REQUEST

Current Zoning: RE-1 (research)
Proposed Zoning: RE-3(O) (research, optional)

SUMMARY OF PETITION

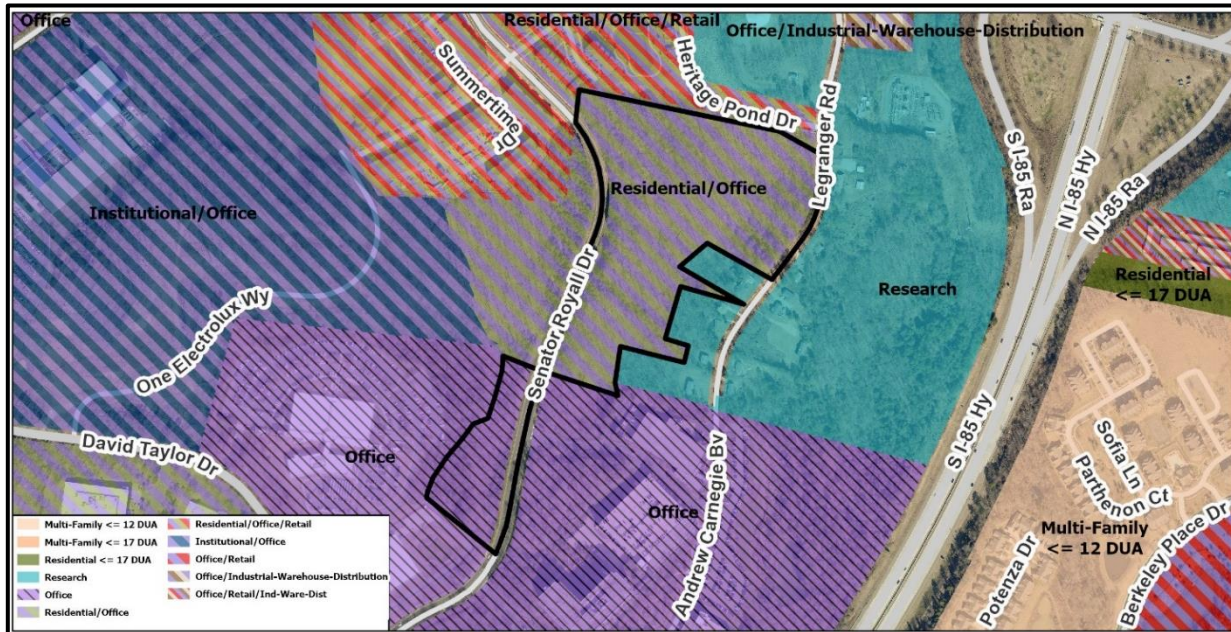
1. ~~Location of curb and gutter needs to be installed per CLDSM standard detail U-04—Local Office/Commercial Narrow Street Typical Section. Pavement reclamation is needed to install this pavement section along the site's Legranger Road frontage. Include the typical section on rezoning sheet RZ-02. The roadway improvement is critical to be consistent with Policy 6 in the City Council adopted University Research Park Area Plan. This improved cross section for Legranger Road will create the appropriate network to support the signal installation project proposed by a separate transportation project.~~ **Addressed**

2. ~~Since the proposed Legranger Road cross-section has been revised to reduce the degree of right-of-way acquisition that may be needed, revise Cross-section 6—Section 'F' to leave the existing right-of-way in place. The proposed improvements will also ensure that the pavement section on Legranger Road meets the typical full-depth asphalt pavement section per CLDSM, Plan Standard U-04/Revision 19.~~ **Addressed**

3. ~~Revise the site plan and conditional note(s) to modify this proposed Senator Royall Place driveway to re-stripe the existing two-way left-turn lane to a dedicated southbound left-turn lane for this proposed driveway. The details can be finalized during permitting, but CDOT advises shifting this access further south to provide spacing to accommodate CDOT Pavement Marking Standards.~~ **Addressed**

4. ~~Widen the proposed 26' public access easements on cross sections A-C to include the proposed sidewalk facilities.~~ **Addressed**
5. ~~Revise conditional note Section 4.c. to clarify that the pavement will meet public street standards and remove the reference that Private Street A will be designed per CDOT standards. CDOT standards do not permit angled head-in parking.~~ **Addressed**

6. ~~Include the pedestrian hybrid beacons, proposed cross sections on sheet RZ-02, and public access easement dedication within the conditional notes.~~ **Addressed**

7. ~~Revise site plan sheet RZ-02, to only provide the information similar to the other cross sections proposed (numbers 1-6; i.e. travel lane, right-of-way, planting strip, and sidewalk dimensions), since CLDSM standards are subject to future revision.~~ **Addressed**
